Your Ref
BN/18/15/HH
Our Ref
PLAN-009921
Date
02/06/2015

Proposal: Single storey rear extension & change in rear fenestration.
Site: Homeville, Lake Lane, Barnham, PO22 0AE.
BN/18/15/HH

Southern Water MapGuide Browser

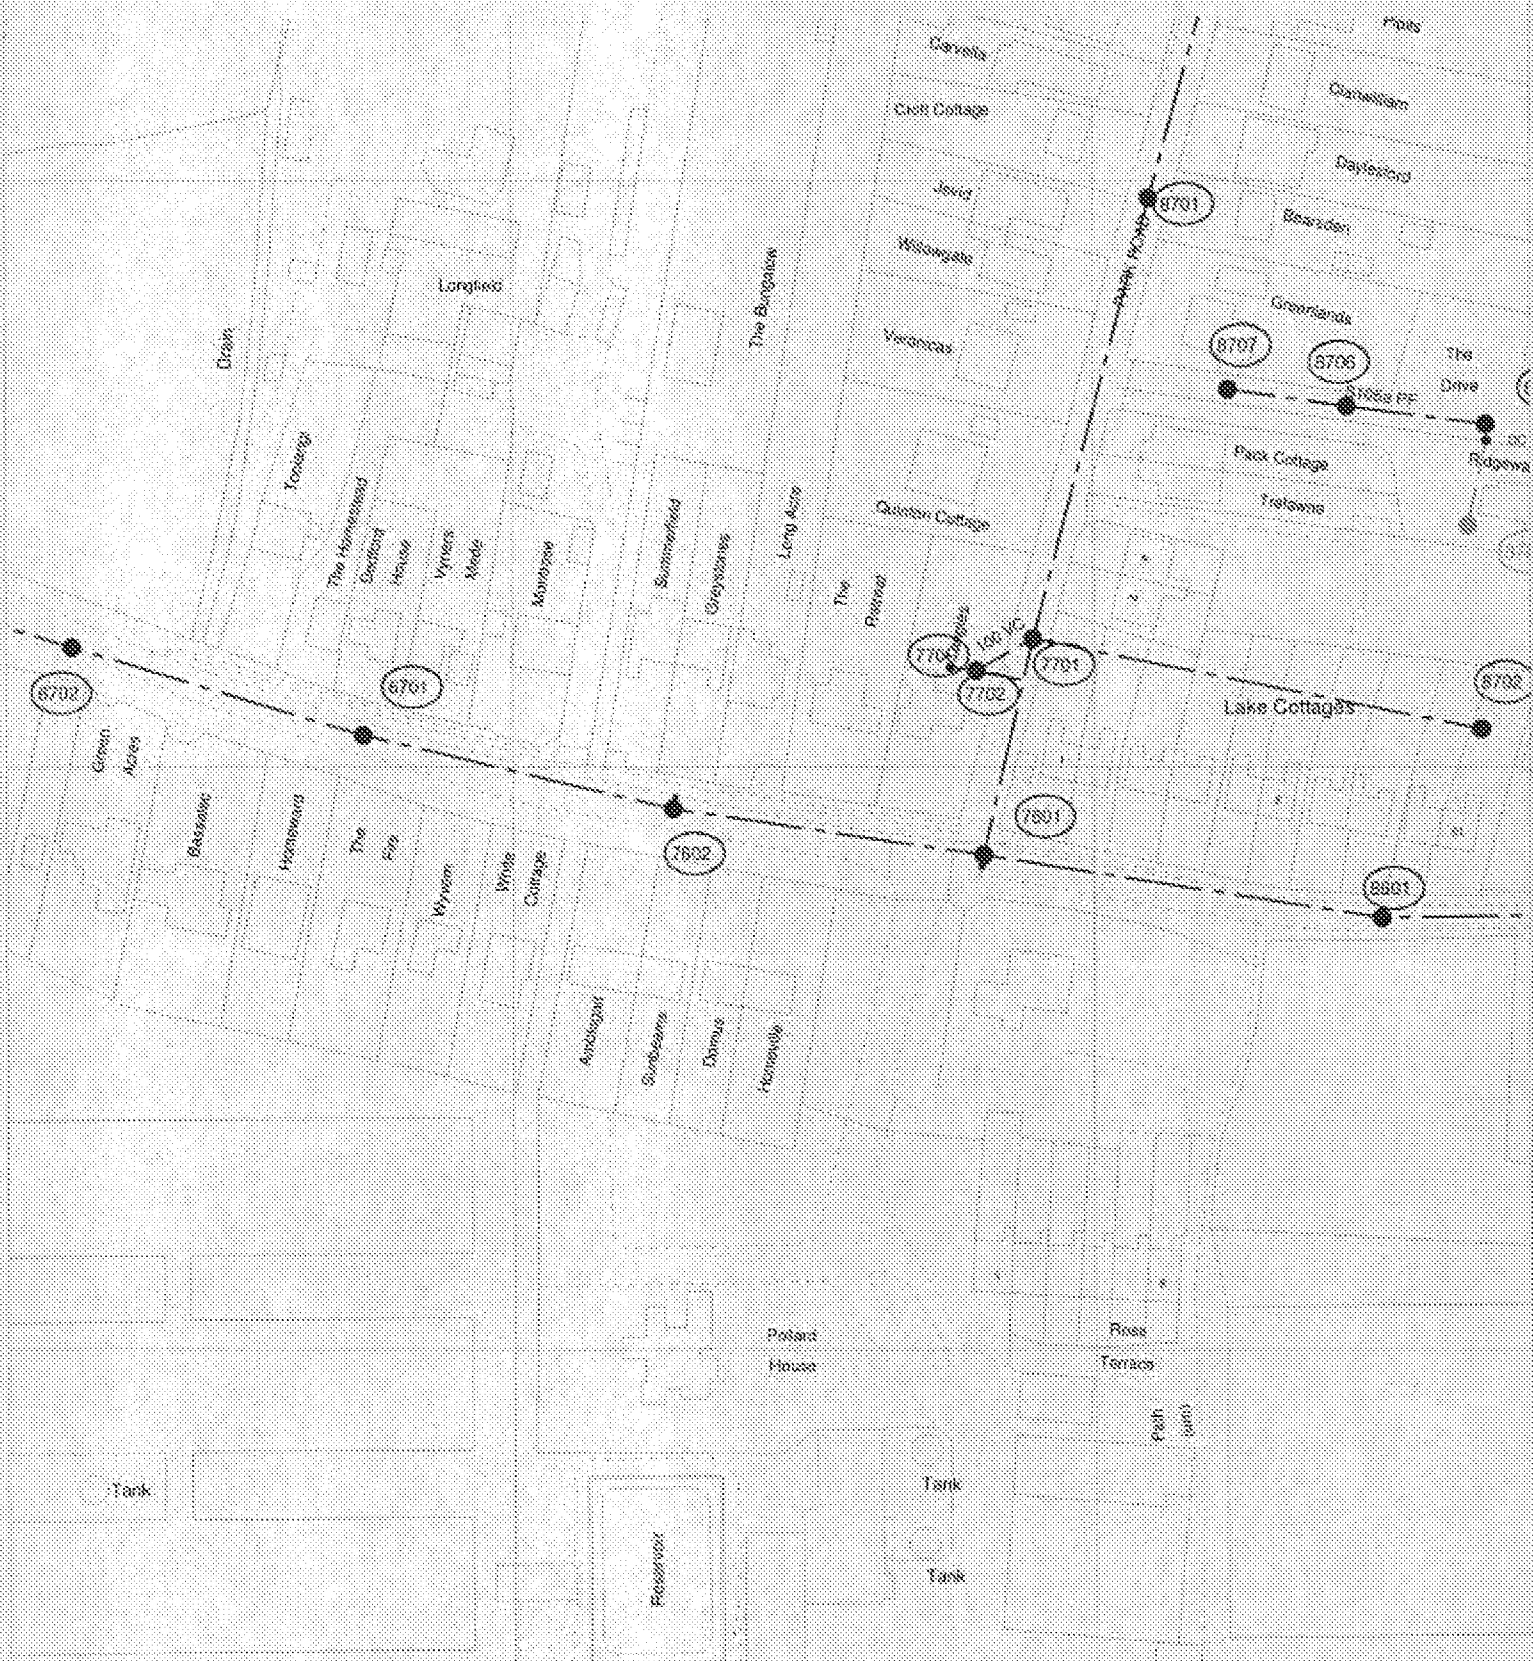
Our initial investigations indicate that there are no public surface water sewers in the area to serve this development. Alternative means of draining surface water from this development are required. This should not involve disposal to a public foul sewer.

Due to changes in legislation that came in to force on 1st October 2011 regarding the future ownership of sewers it is possible that a sewer now deemed to be public could be crossing the above property. Therefore, should any sewer be found during construction works, an investigation of the sewer will be required to ascertain its condition, the number of properties served, and potential means of access before any further works commence on site.

The applicant is advised to discuss the matter further with Southern Water, Sparrowgrove House, Sparrowgrove, Otterbourne, Hampshire SO21 2SW (Tel: 0330 303 0119) or www.southernwater.co.uk.
